### REMARKS

Applicant : Alexei A. Erchak et al.  
Serial No. : 10/723,987  
Filed : November 26, 2003  
Page : 12 of 12

Attorney's Docket No.: 16459-006001 / LD-6

FIG. 14

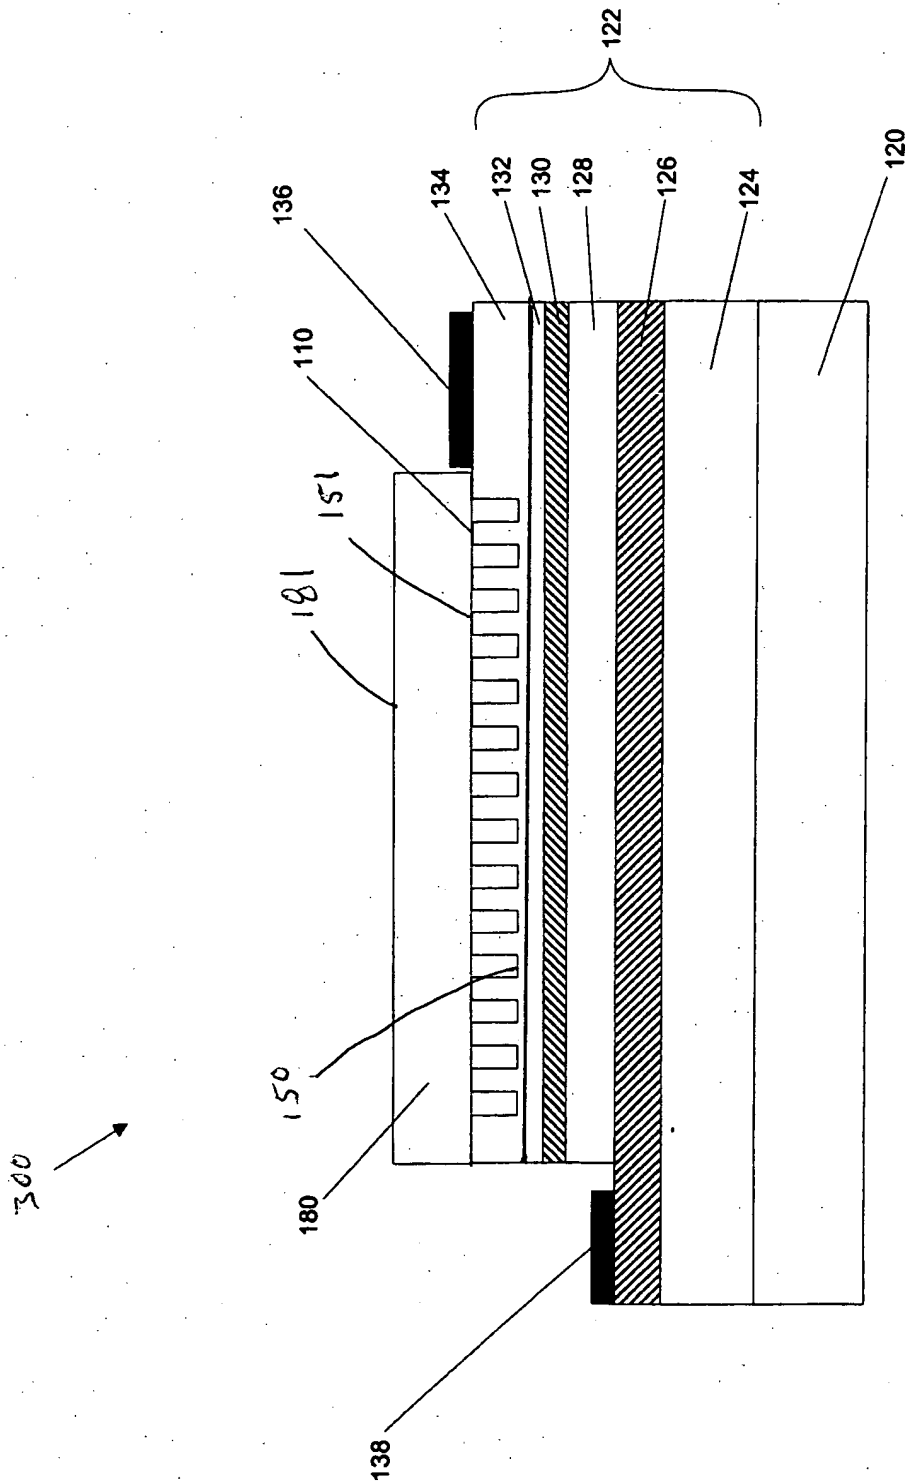
The Examiner objected to the drawings for including certain reference characters (146, 606 and 136) that, in the Examiner's view, were not included in the application as originally filed. However, reference numeral 146 was disclosed in the application as originally filed at page 14, line 12, and reference number 136 was disclosed in the application as originally filed in several locations, including, for example, at page 12, line 30. Applicants amended figure 17 to remove reference numeral 606 and its corresponding layer. Therefore, this objection should be withdrawn.

Please substitute the enclosed 16 replacement sheets of formal drawings for the drawings presently in the application. The attached replacement sheets of formal drawings include changes to Figs. 14 and 17 as indicated in the annotated sheets of drawings that include Figs. 14 and 17. The attached replacement sheets of formal drawings also include newly added Figs. 20-22.

FIG 17

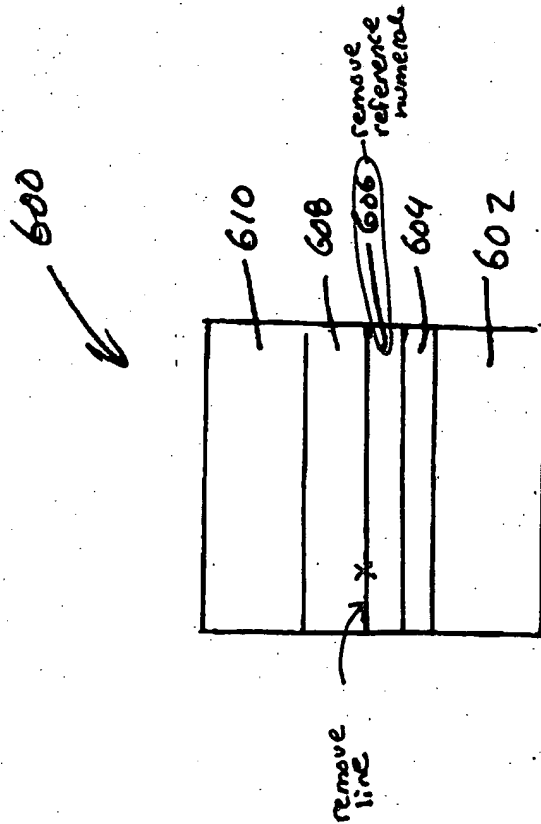
The Examiner also objected to the drawings for failing to show every feature specified in the claims. In particular, the Examiner stated that the drawings failed to show a p-ohmic contact layer between the layer of p-doped material and layer of reflective material. But, this feature is shown, for example, in FIG. 16 and described, for example, in the application as originally filed at page 26, lines 17-25. In addition, the Examiner stated that the drawings failed to show embodiments in which the pattern extends beyond the first layer. Applicants added new FIGS. 20-22 to address this basis of the objection. In view of the foregoing, this objection should be withdrawn.
